**Planning Department
Transportation Development Services**

**Re: Davita Dialysis Center - Albuquerque, 5207 San Mateo Blvd.
Traffic Circulation Layout
(F17-D095A)**

Based upon the information provided in your submittal received 3-04-15, the above referenced plan cannot be approved for Building Permit until the following comments are addressed:

1.2
SHEET 1 OF 2

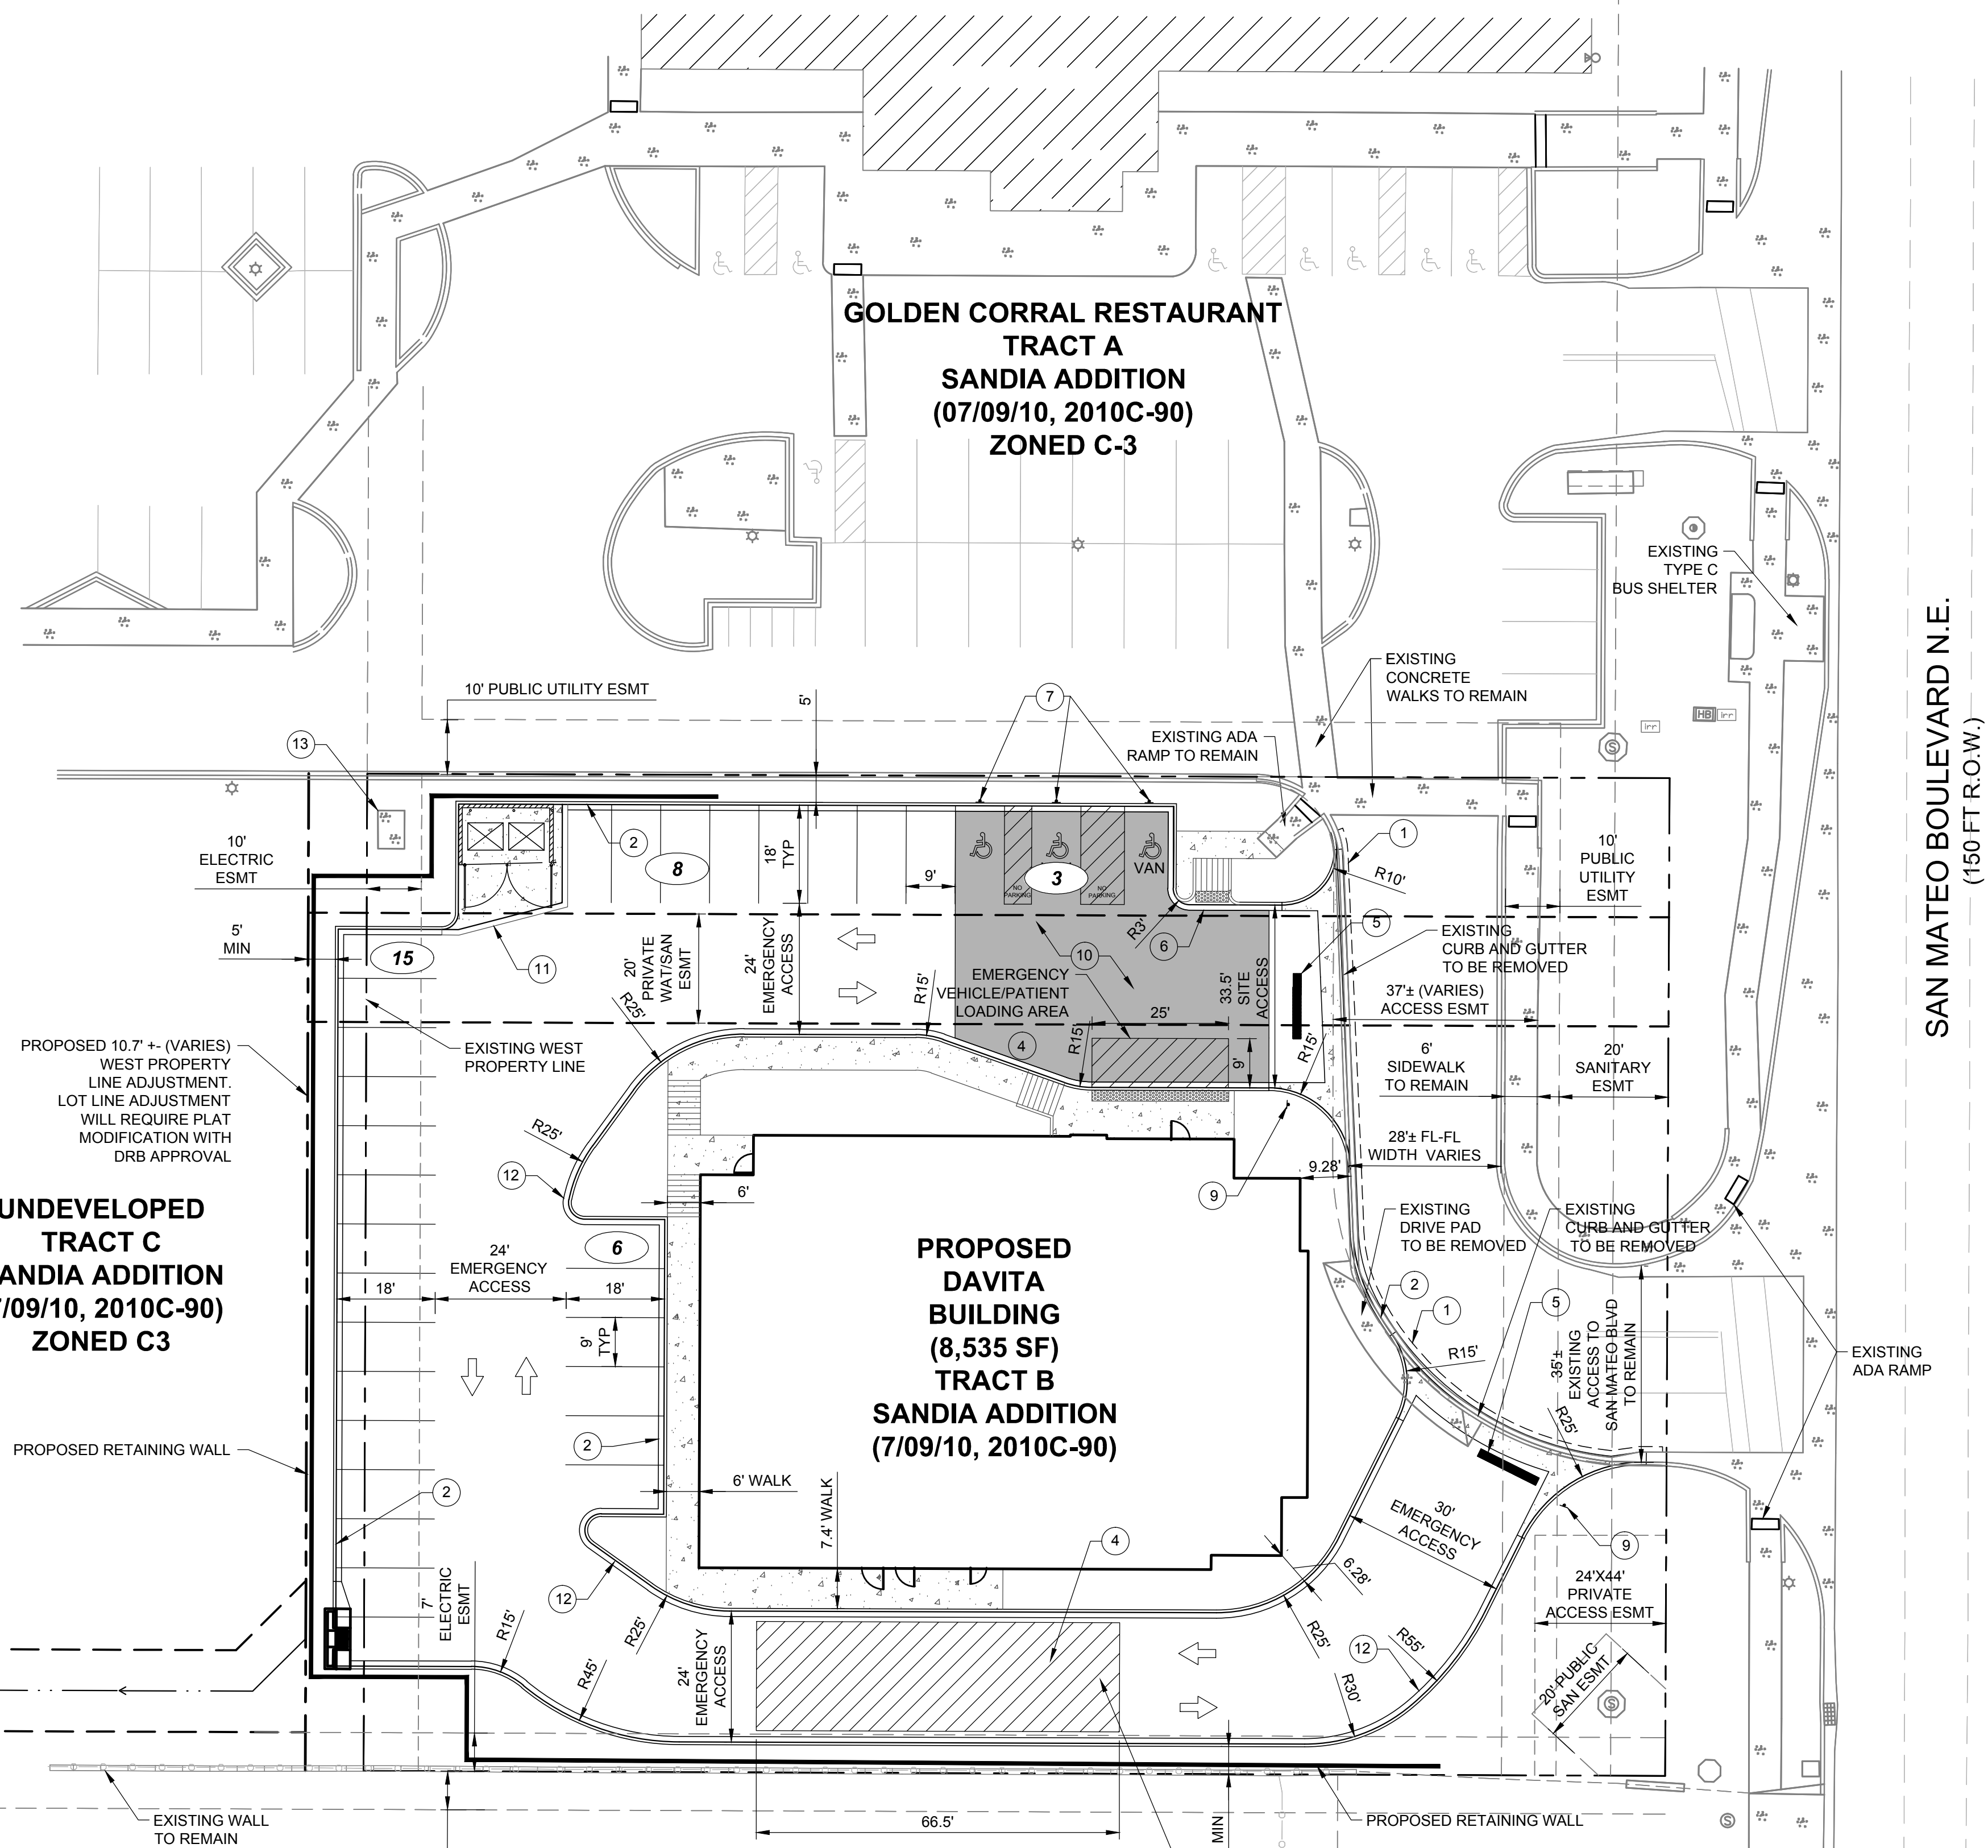
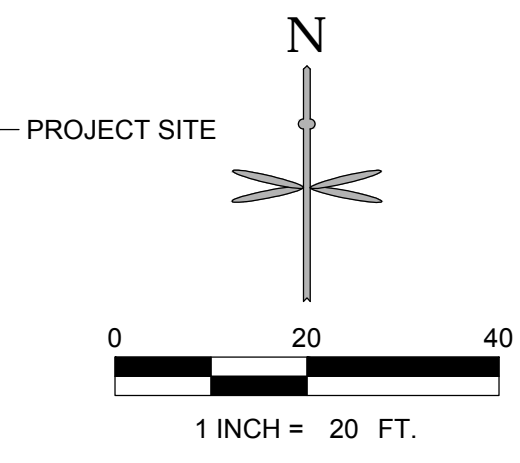
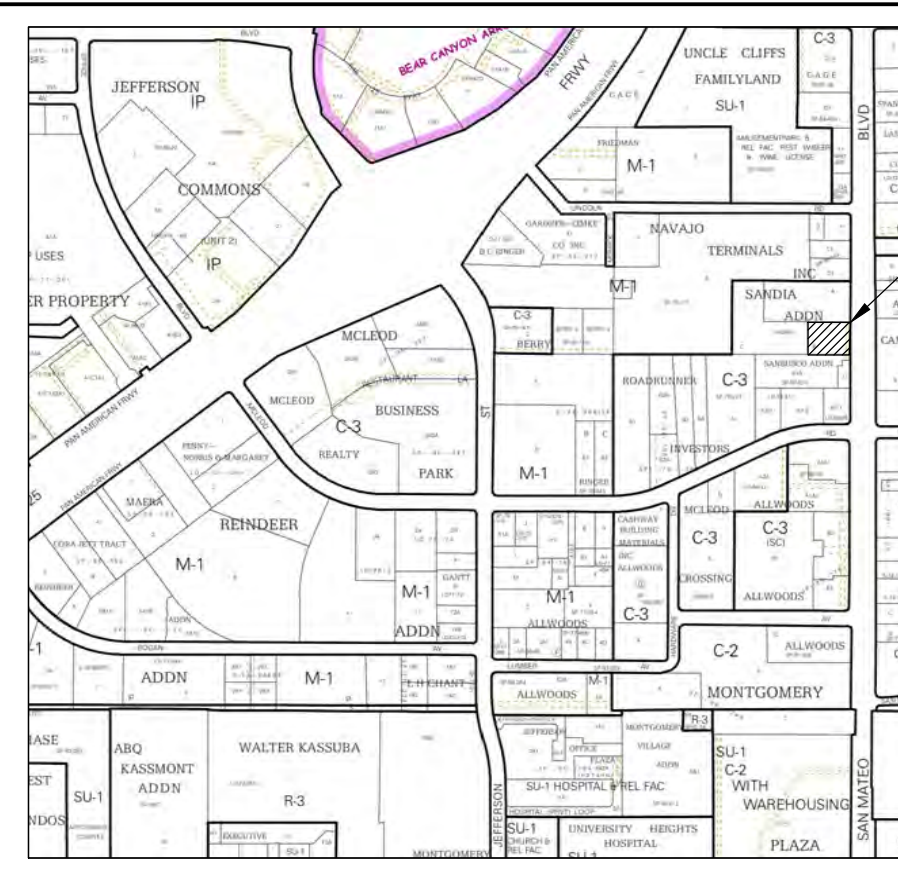
1. For the vicinity map on the plan set, please include a zone atlas page and upsize "McLeod Road" on the map.
2. Clarify the beginning and end of new curb and gutter versus existing curb and gutter at the site entrance off of San Mateo Blvd. Also clarify exact location with text where the new sidewalk begins and ties into existing sidewalk. Where new curb and gutter and sidewalk ties to existing, call out for a smooth connection. Also show where new pavement begins and ends.

3. The traffic circulation layout must be stamped, signed, and dated by an engineer or architect licensed in the state of New Mexico.
4. The traffic circulation layout will not be approved until DRB action is taken to change the location of the west property boundary line.

5. Along the north side of the parking lot, if the standard spaces are all 9 feet wide, label "9' TYP". Do the same along the far west edge of the parking lot.

6. The ADA van accessible sign must have the required language per 66-7-352.4C NMSA 1978 **"Violators Are Subject to a Fine and/or Towing."**
7. Per the DPM, a 6 ft. wide ADA accessible pedestrian pathway is required from the public sidewalk to the building entrances and from the HC parking stall access aisles to the building entrances. Clearly show this 6-foot wide ADA pathway, and if the "Existing ADA Ramp to Remain" needs to be upsized to provide a 6-foot ADA accessible route, remove and replace this ramp to meet

14. Please include two copies of the traffic circulation layout at the next submittal.
 13. Provide motorcycle parking in accordance with the City of Albuquerque Zoning Code 14-16-3-1(C).

12. Provide curb radius for curb just west of Keyed Note 11. (All curb radii for proposed curb should be shown.)
 11. Provide more detail along the north side of the proposed building. Include details of curb ramps along the north and northwest corners of the buildings. Provide sidewalk width along the north side of the building. If truncated domes are being provided for the patient loading area, provide dimensioning for these.

10. Please include a copy of your shared access agreement with the adjacent property owner for Golden Corral Restaurant.
- Please add the following note to the clear sight triangle: "Landscaping and signage will not interfere with clear sight requirements. Therefore, signs, walls, trees, and shrubbery between 3 and 8 feet tall (as measured from the gutter pan) will not be acceptable in this area."

9. Please provide a sight distance exhibit for the San Mateo Boulevard access. (See the *Development Process Manual, Chapter 23, Section 3, Part D.5 Intersection Sight Distance*).
 8. It is not apparent what type of pavement surface is being proposed. A hard driving surface will be required as part of this proposed project for parking area and drive aisles. Show the typical pavement section for the parking lot.
- the 6-foot requirement. Provide a curb ramp detail with necessary dimensioning and slopes.
